# MITIGATION PLAN

## LAUREL SPRINGS SITE

Re: NCIRT Review and USACE Approval of the NCDMS Laurel Springs Mitigation Site / Avery Co./ SAW-2019-00835/ NCDMS Project # 100122

## Response to IRT Comments

**10**

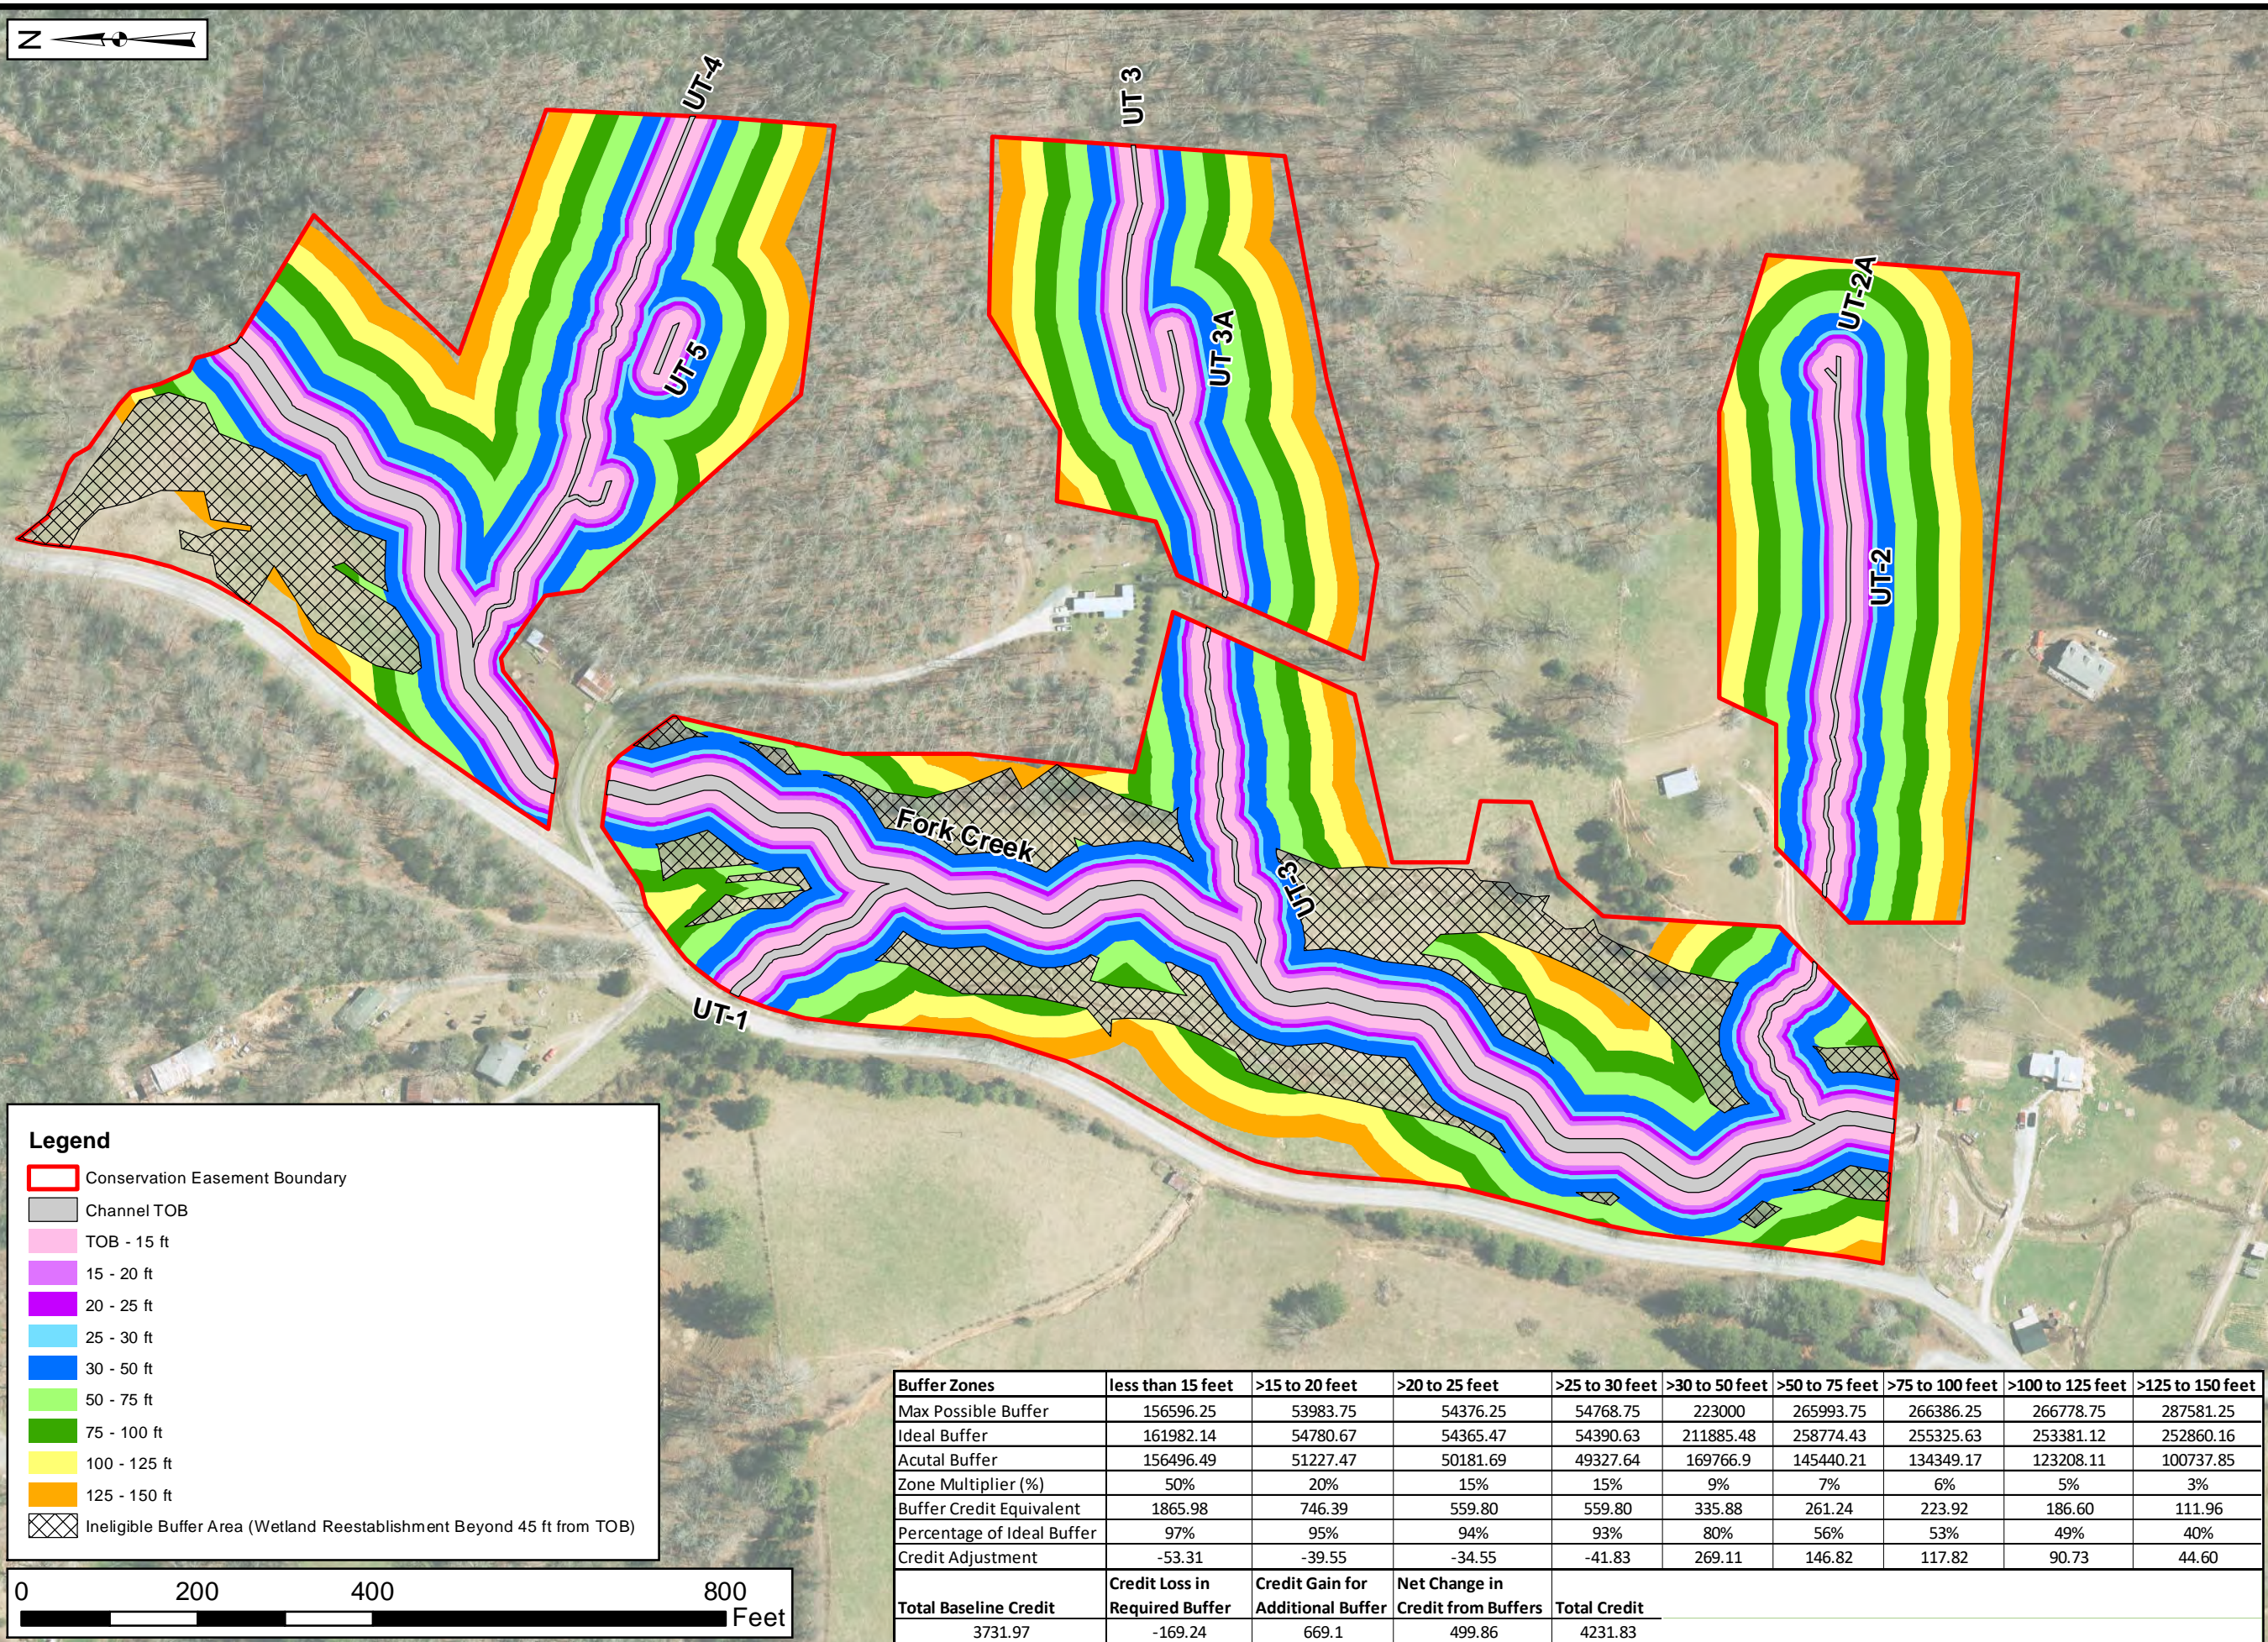
3. Figure 11: Buffer Width Zones- Without being able to review the actual data spreadsheet, it's difficult to determine whether terminal ends were accounted for. In the table provided it appears you used the old version of the buffer tool. The new version allows terminal ends where the project enters or exits the property to be exempt from counting against you. Please re-run the buffer tool to account for the crossing terminal ends, clip creditable wetlands from the actual buffer, and correct the length entered in the spreadsheet. Please provide a printout of the actual spreadsheet. Also, please provide a map that depicts the idea buffers. I'm happy to meet with you if you need additional explanation. Please provide this information for review prior to submitting the final mitigation plan and 404 permit to avoid review delays.  
Files were provided to Kim B. on 02/05/2021. Attached to this comment response is her response, approving the revision.

The buffer figure and table has been updated and included in the document and electronic submittal.

Title:  
**LIDAR  
 MAP**

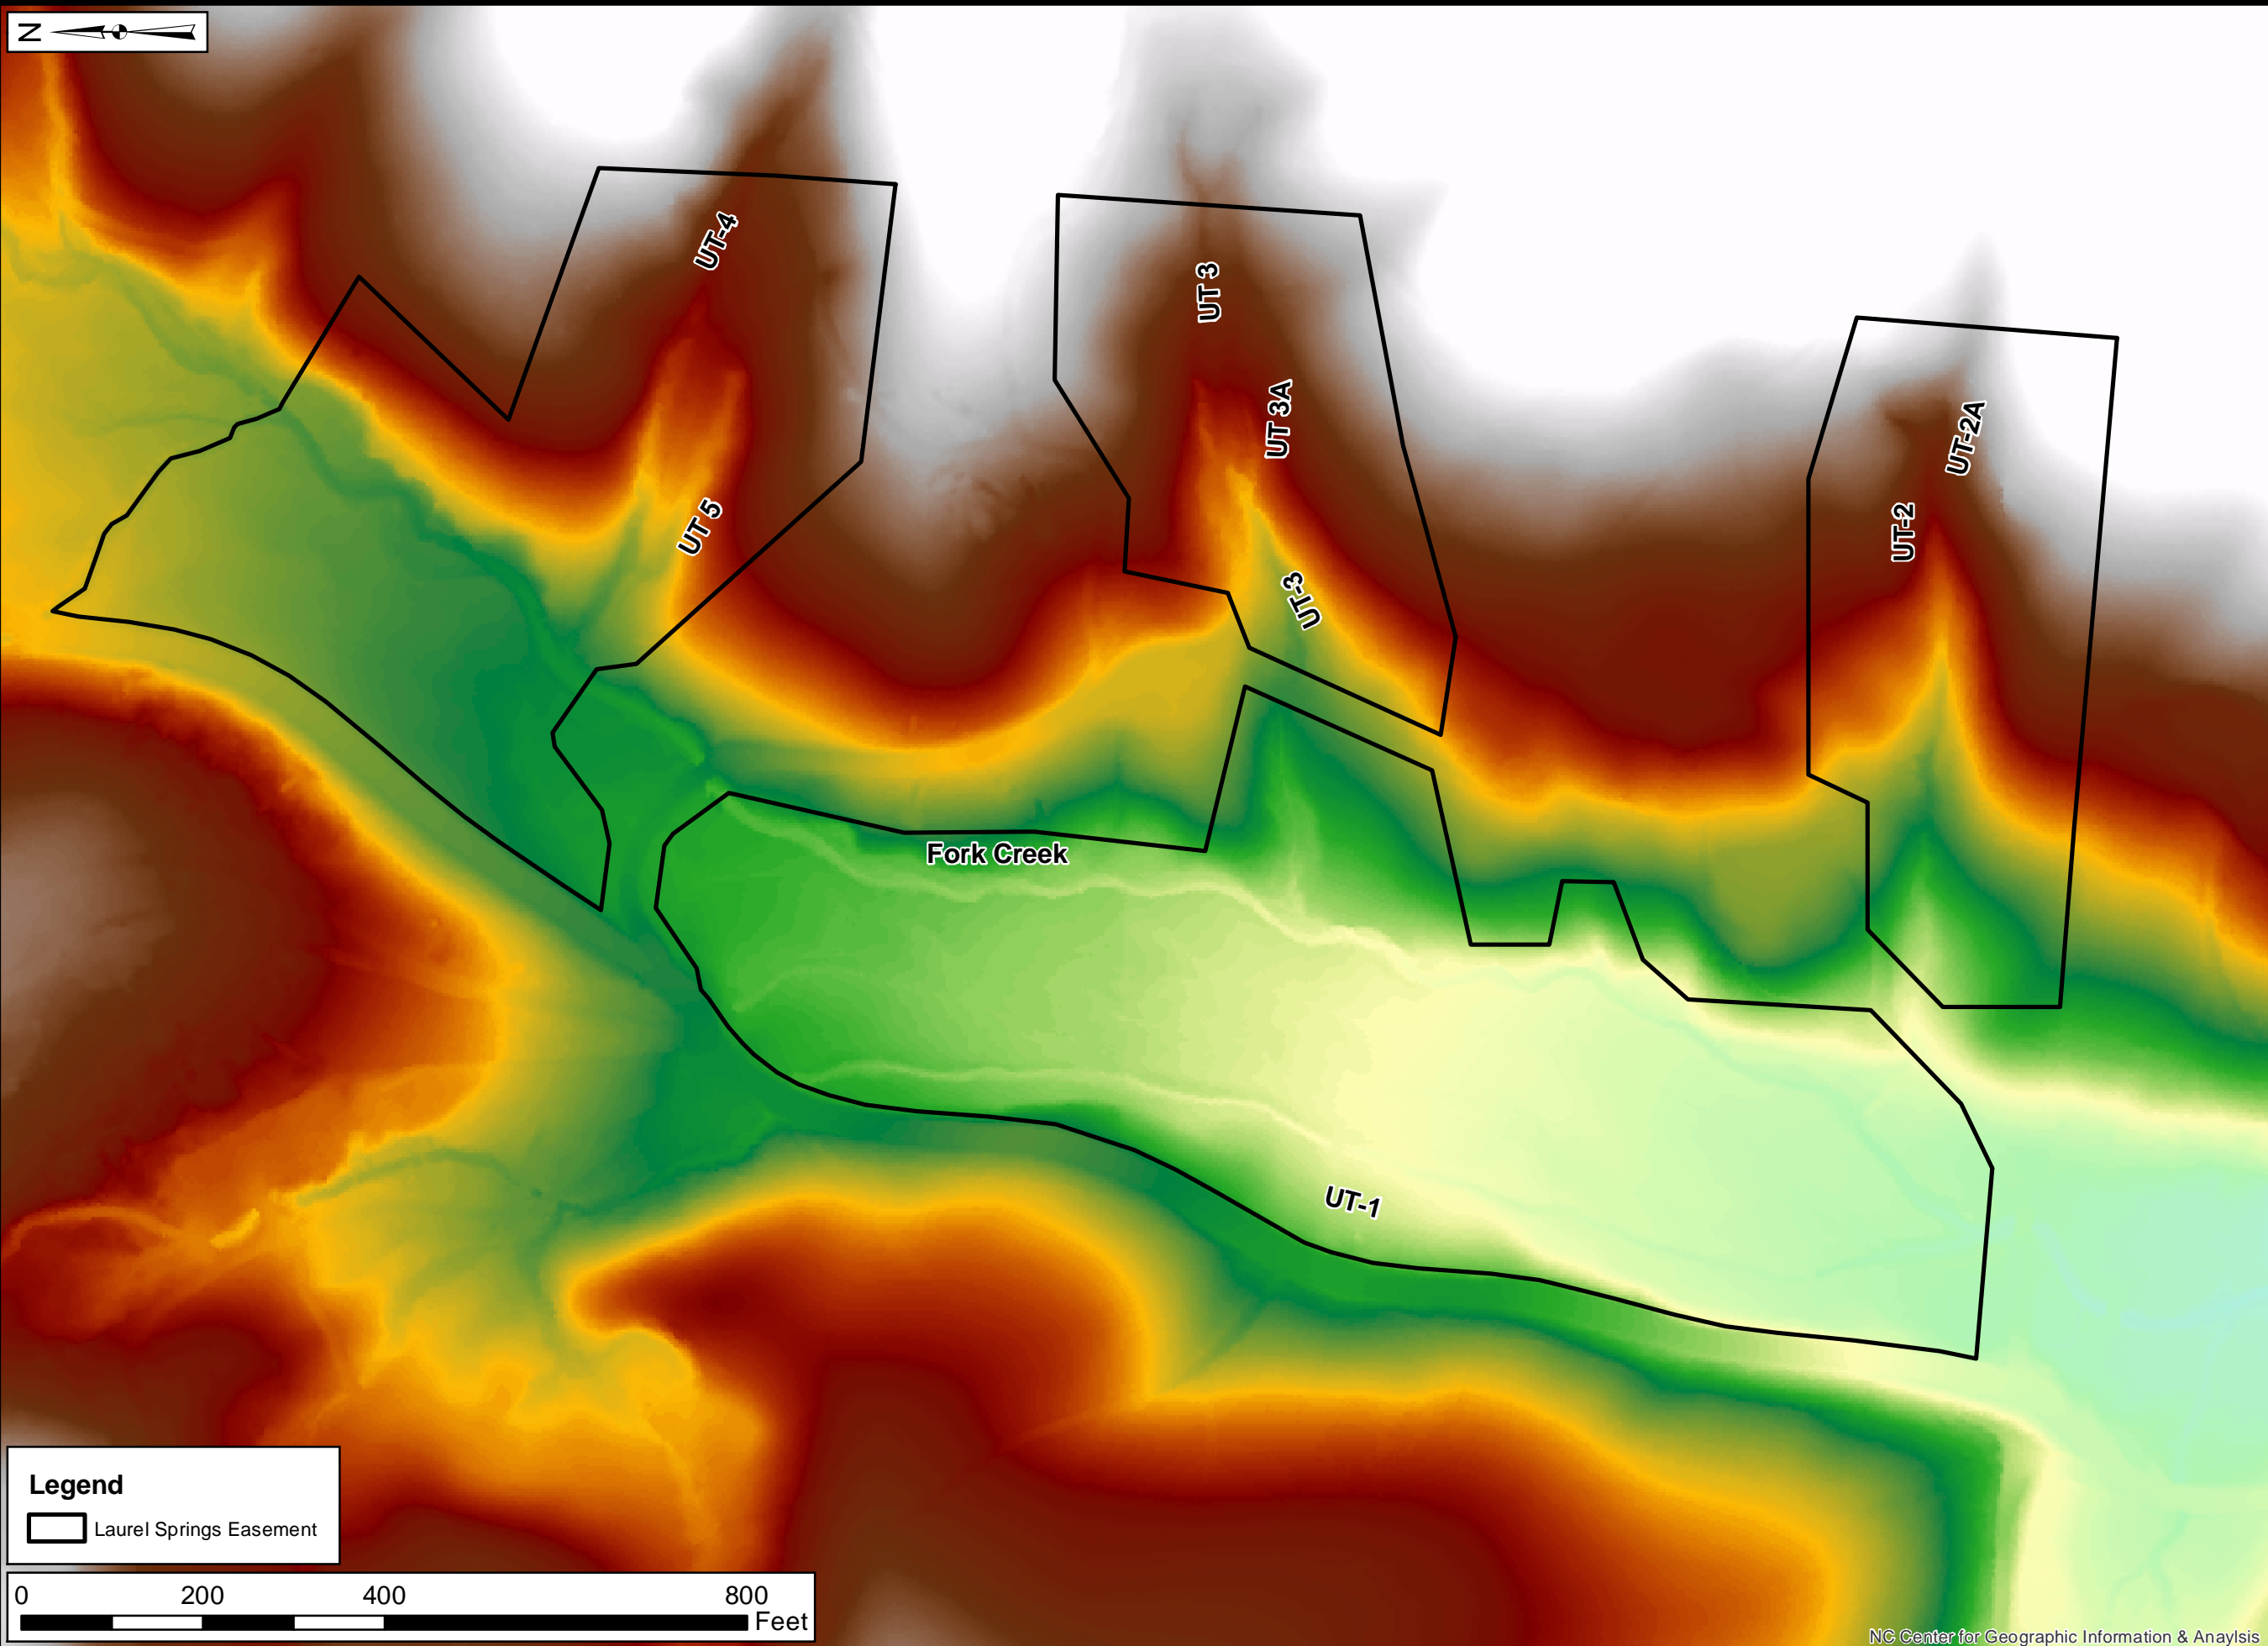
27. Figures – DWR would welcome the inclusion of LiDAR and historic aerial figures, as well as drone and ground photos of existing site conditions. All of these items are helpful in our review.  
[A Lidar figure was added to the appendix as Figure 11.](#)
